**Meeting – Public Safety Building Option D Discussion:**
**004.01 Status of Design Process**

The following notes refer to the attached spread sheet KFD Chief Comments with RDC Responses dated 10/28/2020 and Option D Plans Annotated During the Meeting dated 10/29/2020

KENSINGTON PUBLIC SAFETY BUILDING

**FIRST FLOOR OPTION D**

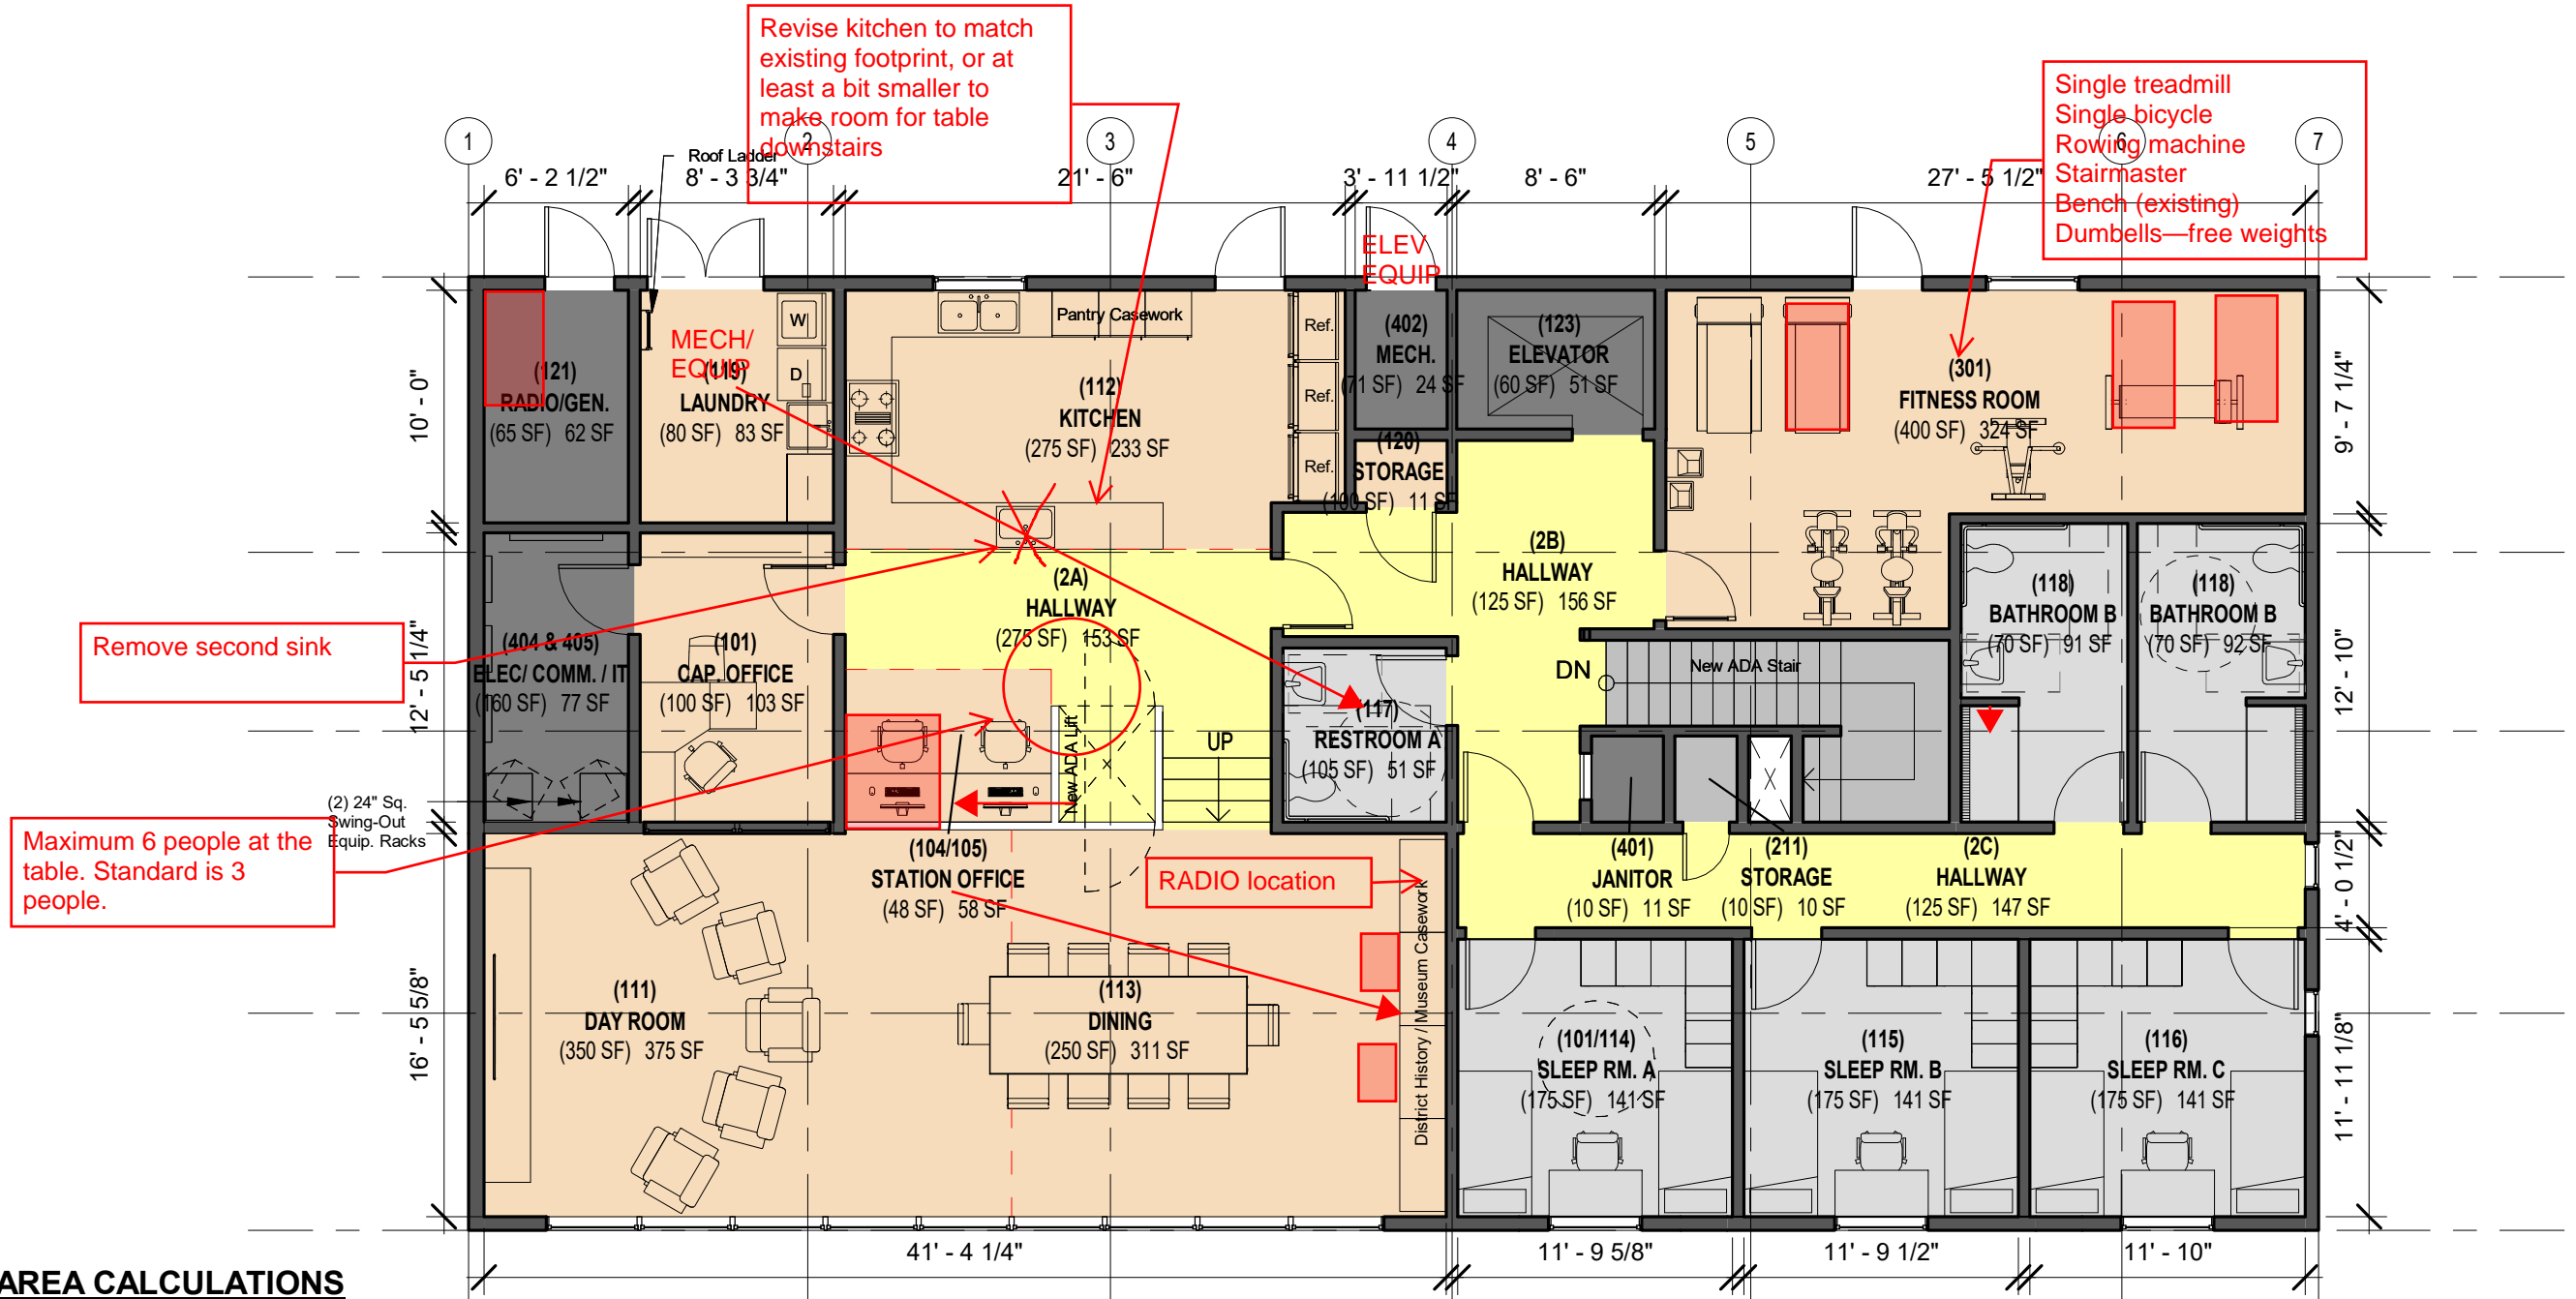
- a. It was requested that the interview room on the first floor return to being a shared space between the KFD and the KPD. A door to the Lobby would be added and the door to the PD area removed. This will be run by the KPD as well.
- b. The space is not large enough to be used as a DOC. MM suggested space could be leased offsite for use as a DOC. MC commented that this will need to be an essential services facility type of construction.

- a. It was decided that storage cabinets should remain along the east wall at the back of the south app bay. The existing sink in this area will be removed. The existing cabinets may be reused if possible.

- a. It was decided that the Kitchen size should match the existing Kitchen foot print. This will provide more room for a dining table adjacent to the kitchen. Kitchen casework may need to be reconstructed to meet ADA accessibility codes.

2	<ul style="list-style-type: none"> <li>• These plans do not show a shared conference room which means that the fire personnel do not have a location to meet with the public. The upstairs is for the most part the crews living quarters and it is not a good practice to bring them into the private area. This is even more prevalent with pandemic issues which may be the new normal? I strongly believe there needs to be a joint conference room like there is now for meeting and for emergency DOC's.</li> </ul>	<p><i>A shared Conference Room, to conform with police facility standards, should be located outside of the KPD restricted area. The dedicated Victim/Witness room for the PD can once again be shown as a shared PD/FD conference room. The plan revision to achieve this is relatively easy. This will required a redesign of this first floor area to accommodate this request and confirmed with the KPD.</i></p>

NO	KFD COMMENT	RDC RESPONSE
4	<p><b>PREFERRED</b></p> <ul style="list-style-type: none"> <li>Removing the storage cabinets behind the two engines is further limiting areas to store supplies. I am all for removing the stainless-steel sink from the one and putting doors back on it. While more room is always preferred, the access as it stands is acceptable considering the value of the storage area.</li> </ul>	<p><i>Storage cabinets may be placed as you deem appropriate. We recommend confirming the exact size of the apparatus vehicles to ensure clearances. We also recommend using cabinets that are moveable, in the event larger vehicles are needed in the future.</i></p>
5	<ul style="list-style-type: none"> <li>It appears that the Kitchen is being made wider than it is. The switch with the pantry and refrigerator makes sense but changing anything else is just adding cost as the stainless-steel countertops will all have to be remade.</li> </ul>	<p><i>The Kitchen layout can remain in its current configuration. The countertops can only be 34" high to meet accessibility codes. This may necessitate reconstruction of all or part of the casework</i></p>

**SECOND FLOOR OPTION D**

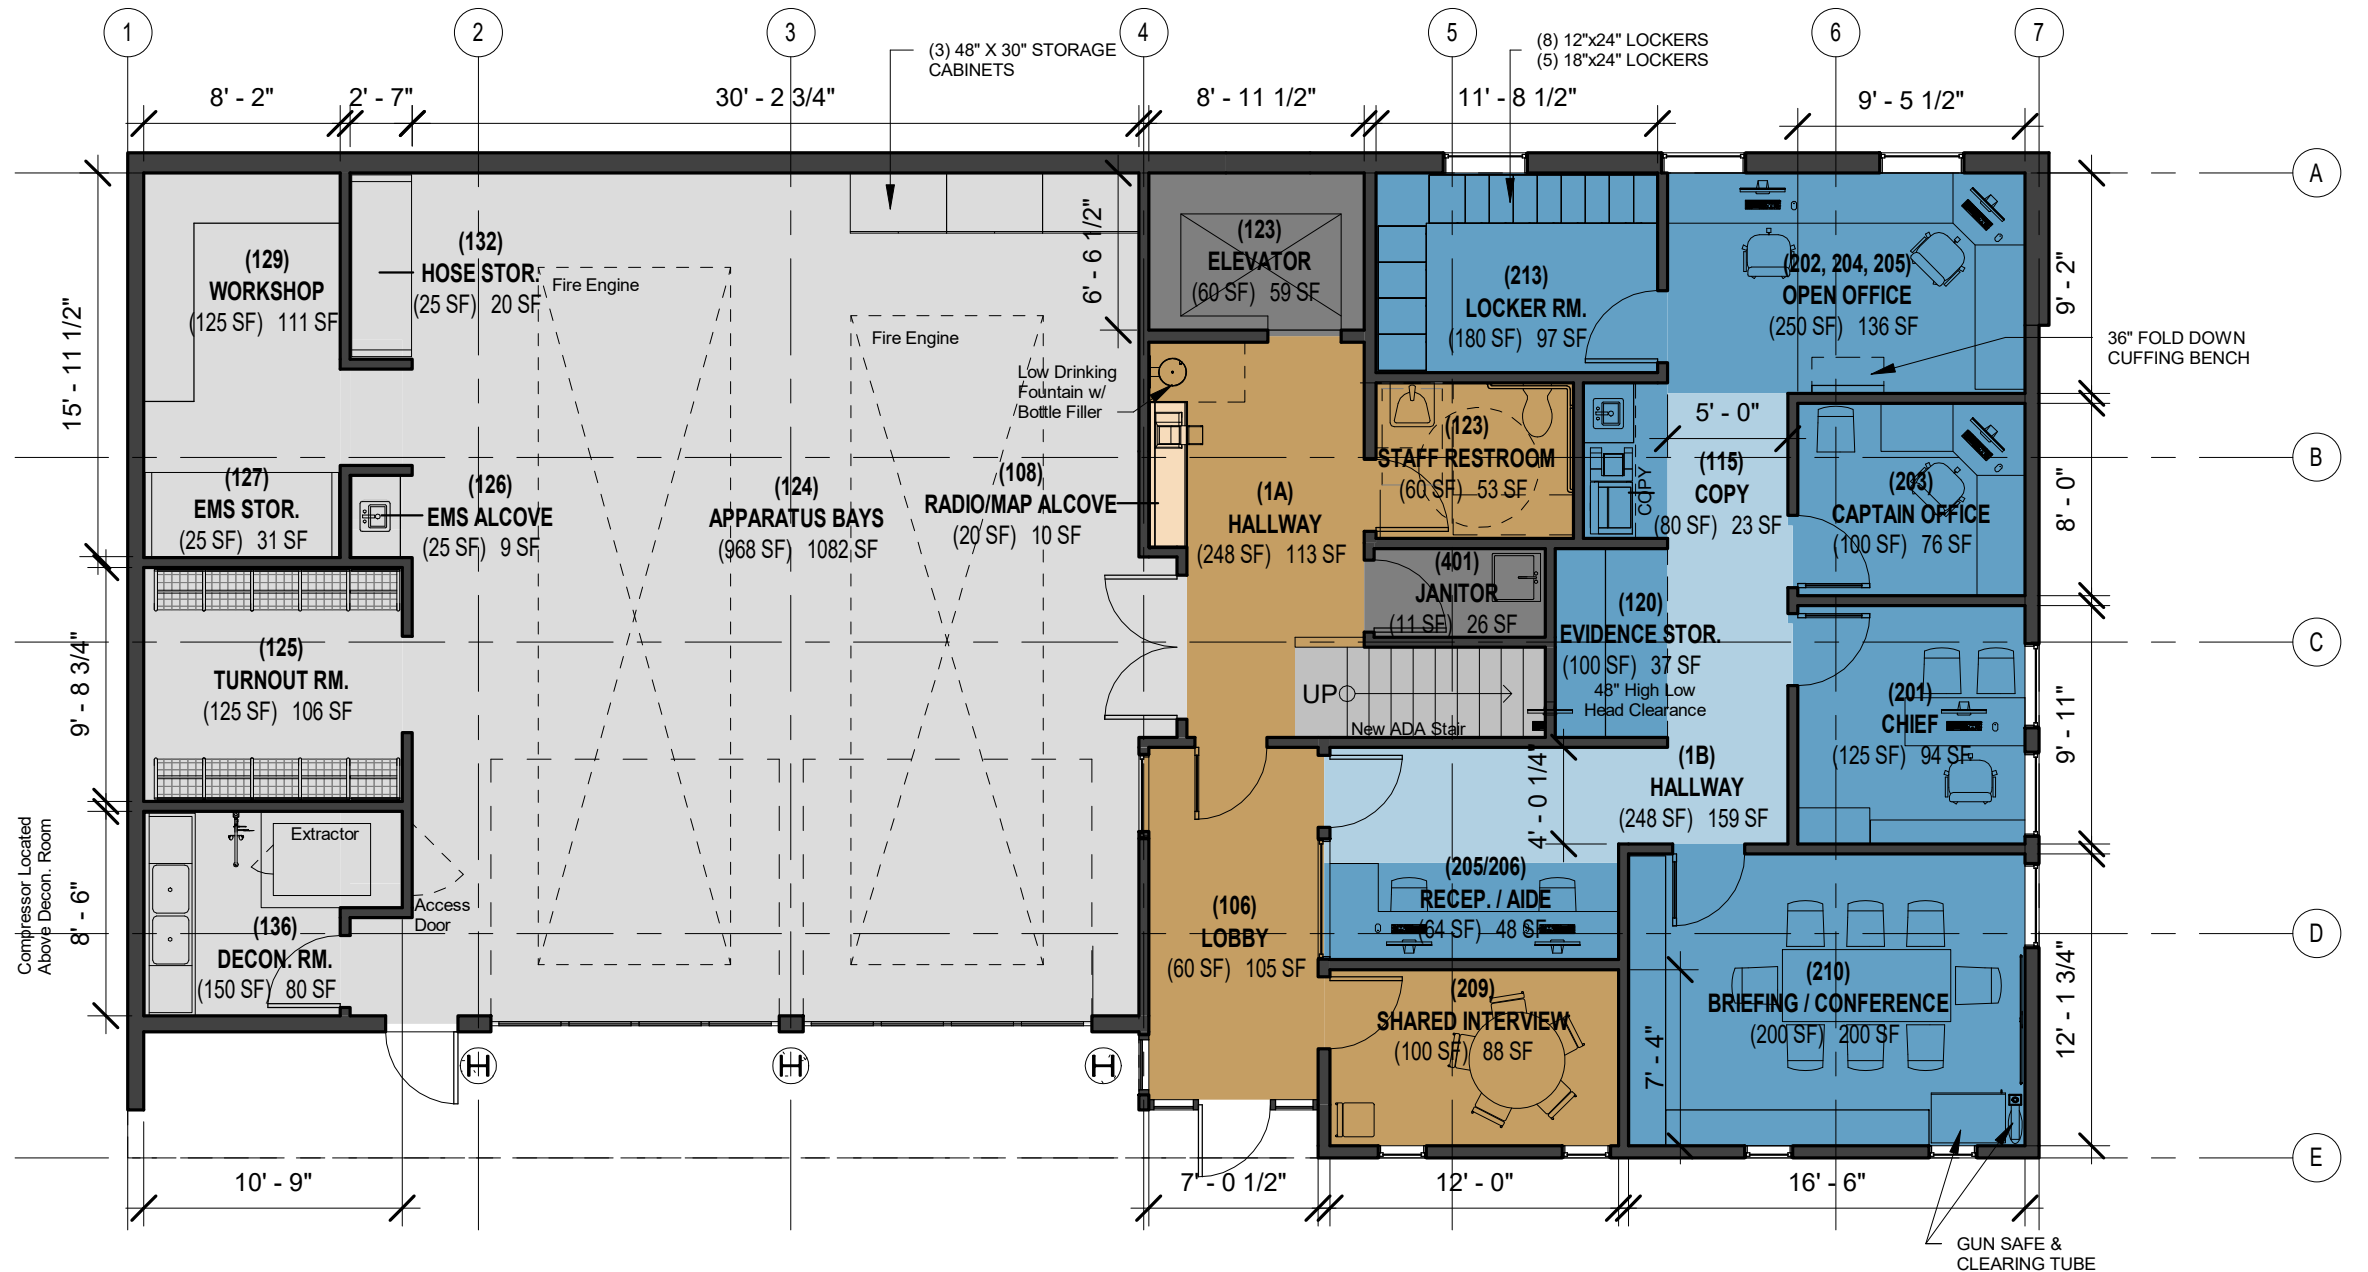
- a. It was decided that the Laundry Room will be moved to the location of the second floor restroom.
- b. The existing laundry room will be used for mechanical equipment displaced by the elevator.
- c. A detailed analysis of the code required plumbing fixture has not yet been completed. This may limit the ability to remove the restroom.

- a. It was decided to add a radio communications station on the Dayroom upper level on the south wall.
- b. Radio chargers and printer can be located in the Map Alcove in the first floor hallway.

- a. It was decided that the second sink is not needed in the Kitchen.

- a. It was decided to move the station office functions to the upper Dayroom south wall.
- b. The wheelchair lift will be moved to the north. A round table will be placed between the lift and the stair. The table needs to seat a maximum of six, with three seats required on a daily basis.

- a. It was determined that the Bathrooms cannot reduce in size and still meet ADA codes. The Fitness Room cannot increase in size.
- b. The Fitness Room Equipment includes: 1 treadmill, 1 stair climber, rowing machine, weight lifting bench, weight storage, dumb bell storage.

NO	KFD COMMENT	RDC RESPONSE
1	<p><b>MUST HAVE</b></p> <ul style="list-style-type: none"> <li>• Only having access to the laundry room from the outside is not feasible or acceptable. First most laundry is done in the late evening (dark) so our personnel will be outside in the dark (or dimly lit) carrying items and negotiating the step ups (trip hazard) let along getting wet when it rains. Additionally, since the District is having to make the second floor ADA complaint, the laundry room will not be complaint with the since the access will have step down and step ups</li> </ul>	<p><i>The Laundry Room is currently not ADA accessible, either from interior or exterior points of access. It can be made accessible from the interior if the floor height is structurally altered, and the Captain's office is moved to another location. Or, it can be made accessible from the outside with level modifications, and overhead weather protection for access during inclement weather. Alternatively, the laundry room could be relocated to replace Restroom A (117). This third restroom was added for public use assuming that the public (vendors, etc.) would be coming upstairs for meetings, but if the downstairs meeting room is once again shared, the public can use the downstairs restroom, freeing up this space. Alternative locations for the Captain's Office are not as clear, with the option of moving it to the Captain's sleep room being the most likely alternative.</i></p>

3	<ul style="list-style-type: none"> <li>• What area is being proposed for the phones and printers that are current at the door leading to the stairs from the kitchen?</li> </ul>	<p><i>Currently these would either be located in the station office workstation area on the second floor or in the Map Alcove in the shared hallway on the first floor.</i></p>

6	<ul style="list-style-type: none"> <li>The drawing shows a second sink in the kitchen in front of the pass through window? This is not needed.</li> </ul>	<p><i>The added sink may be removed</i></p>
7	<ul style="list-style-type: none"> <li>I still prefer a dining table closer to the kitchen like the way it is now. This design required our personnel to go up and down stairs carrying dishes, pans, etc. when setting or clearing after a meal. We do not need a table to serve 10 people as is currently drawn, so perhaps the workstations can be put on the upper level and fit a table for 4 closer to the kitchen.</li> </ul>	<p><i>It is possible to revise the design to add a small table next to the wheelchair lift and move the workstations to the upper level with the Dayroom.</i></p>
8	<ul style="list-style-type: none"> <li>A wider or larger workout area would be preferred as I do not believe what is drawn is large enough and we will end up like we are now with moving equipment into other areas such as the day room. Currently there is the weight machine, Stairmaster, treadmill, rowing machine, loose weights, dumbbell rack and stationary bicycle. Perhaps the bathrooms can be a little smaller by pushing the toilet and sink closer?</li> </ul>	<p><i>There is currently no space in which to expand the Fitness Room. The Bathrooms cannot be reduced in size and meet accessibility codes. The current distance between the toilet and the sink is the minimum distance allowed by code.</i></p>
